Bad Chip Detectors Must Go!

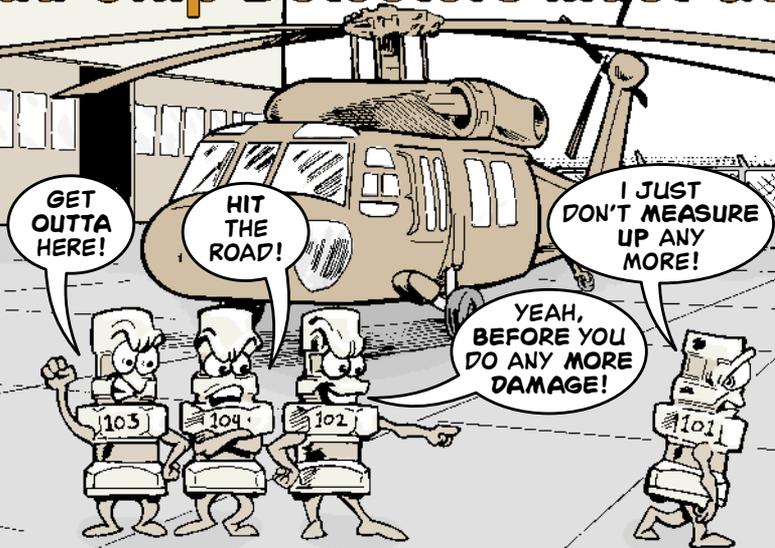
Do **NOT** use chip detector, part number (PN) 70351-08249-101, in the UH-60A/L accessory module or in the UH-60L input module. Its probe is too short to open the self-closing valves in these modules. That means oil and metal chips do not pass the detector. The result is that there may be delayed warning of an impending failure of an internal component.

Dispose of all on-hand stock of the bad chip detectors and inspect all Black Hawks to see if any are installed. The bad chip detectors have PN 70351-08249-101 stamped on the electronics pod attached to the end of the chip detector cable. The vendor number—G5034—is stamped on the end of the chip detector probe.

If you find bad chip detectors, replace them. The current TM 1-1520-237-23P-2 (Nov 98), shows PN 70351-08249-103 (NSN 1615-01-263-8725) as the replacement. But, PN 70351-08249-102 (NSN 1615-01-106-1944) is also OK.

The TM will soon be updated to add PN 70351-08249-104 (NSN 1615-01-459-7960) and the following:

Do not use PN 70351-08249-101 chip detector. If installed, replace with chip detector PN 70351-08249-104.
